Pwyllgor PWYLLGOR CYNLLUNIO

**Dyddiad ac amser
y cyfarfod** DYDD IAU, 3 TACHWEDD 2022, 1.30 PM

PLANNING COMMITTEE**3RD NOVEMBER 2022**AMENDMENT SHEET

AGENDA ITEM 5c	PAGE NO. 61
APPLICATION NO:	22/01719/MJR
LOCATION:	Cantonian High School, Fairwater Road, Fairwater
PROPOSAL:	Erection of Temporary Replacement School Buildings (Between One and Three Storey in Height), Including Administration, Kitchen/Canteen and School Hall Buildings; Temporary School Car Park and Footpath From Fairwater Road to Doyle Avenue (All Temporary Works) Together With Permanent Enabling Works to Facilitate the Redevelopment of Cantonian High School Comprising Boundary Fencing, Spectator Stand, Installation of Sports Pitches, Multi Use Games Areas and Associated Floodlighting and Fencing, Associated Landscaping, Drainage And Engineering Works.

Austin-Smith:Lord
 Project: Fairwater Campus
 Description: Enabling works- General Arrangement
 Job No. Drawing No. Revision P13
 Project Number FC- ASL- ENW- XX- DR- L- 09101

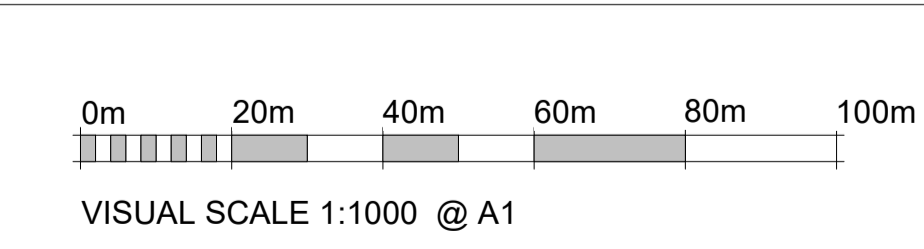
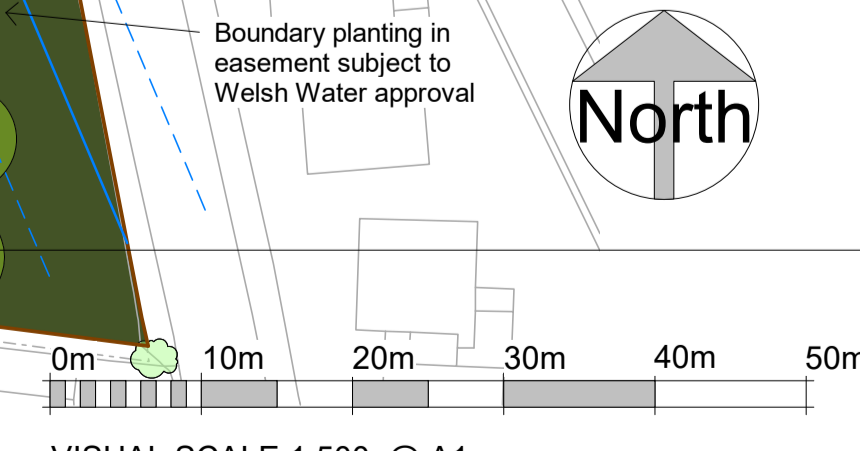
The agent (Asbri Planning) has submitted amended Plans responding to Transportation Officer comments, showing minor alterations to access points off Doyle Avenue and bus tracking diagrams.

The Transportation Officer advises that the amended plans are acceptable.

That condition 3 (Approved Plans) is revised to reflect the amended plans as follows:-
